# TOWN PLANNERS

**RE: Craigieburn West Precinct Structure Plan (PSP)**  
**Submissions made on behalf of [REDACTED] Whites Lane, Yuroke (Mickleham)**  
**PSP property ID 16**

Figure 4 Proposed waterway corridor - Aitken Creek Waterway Values Assessment, December 2020 – subject site dashed red

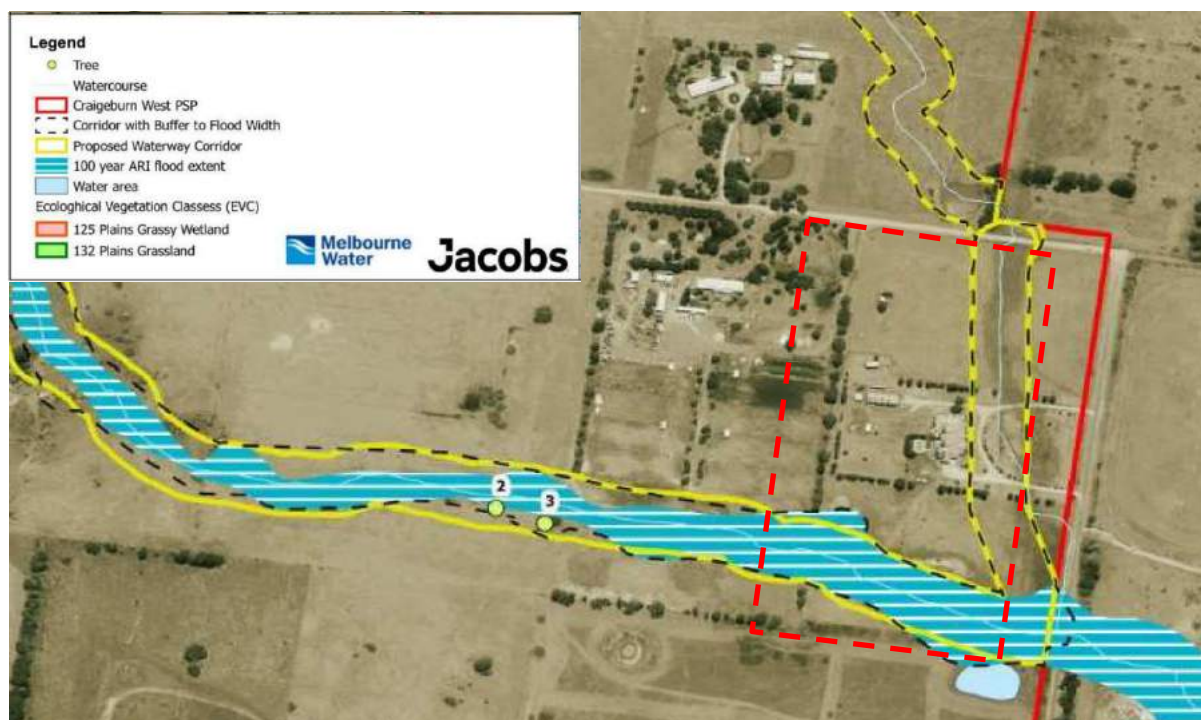
- 4.1. The blunt application of the minimum corridor widths in the absence of a robust site specific assessment does not represent a sophisticated solution for this section of the north-eastern tributary as it relates to our client's site;

- 4.2. This section of the north-eastern tributary has been assessed to have limited ecological values;
  - 4.3. No presence of significant vegetation (such as River Red Gums) is located along this section of the north-eastern tributary;

- 4.4. No rare or threatened flora and fauna was found (or likely to be found) along this section of the north-eastern tributary;
  - 4.5. There is merit in considering an 'online' stormwater treatment in lieu of the proposed 'offline' treatment for the north-eastern tributary given the steep topography, and therefore opportunity to reduce the minimum corridor widths associated with the proposed asset – e.g. the existing online treatment successfully utilised at Flax Lily Creek to the south of Craigieburn Road;

Figure 5 Proposed buffer widths and locations - Aitken Creek Waterway Values Assessment, December 2020 – subject site dashed red

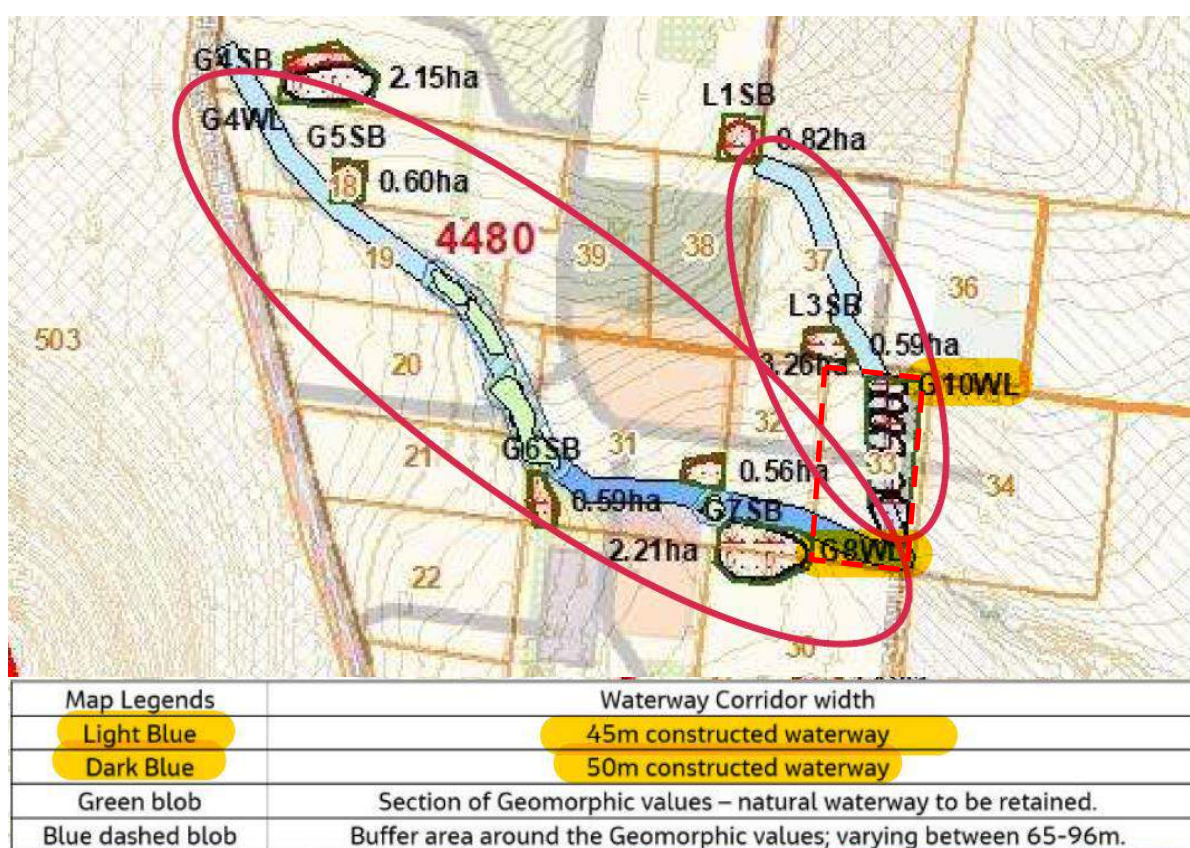
14. The proposed asset (G10WL – wetland) along the eastern portion of our clients site equates to a catchment area of 88.9 ha, with 0.7 ha surface area and a footprint area of 3.26 ha (including 1.8 ha within the waterway corridor).

Figure 6 Aerial map of Flax Lily Creek and proximity to our client's site (Nearmap, 2020)

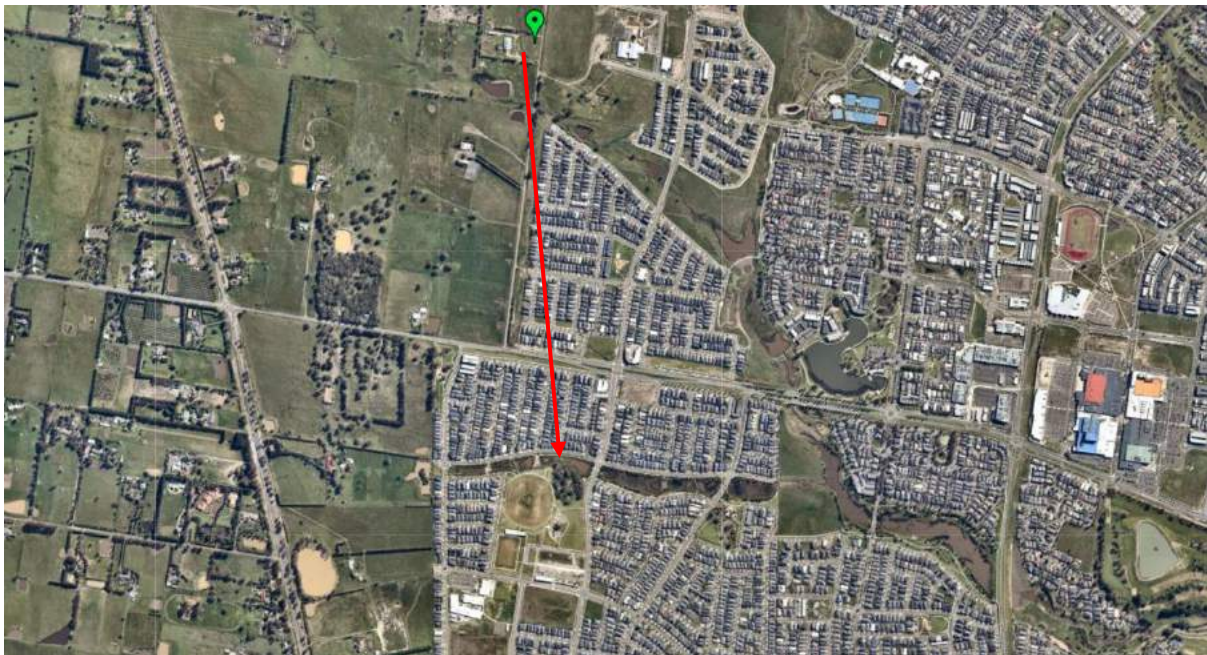
- 18.5. **Stormwater treatment assets and erodible soils** – There is merit in considering an ‘online’ stormwater treatment for this section of the north-eastern tributary, which is generally adopted by Melbourne Water for areas which exhibit steep topography. An online stormwater treatment would allow for the built assets to be accommodated within the waterway, in lieu of extensive works and excavation required to situate the required ponds etc along the steep banks – which would ultimately result in a preferred outcome for areas exhibiting erodible soils. An online stormwater treatment has been successfully implemented at Flax Lily Creek to the south of Craigieburn Road (see below figure).
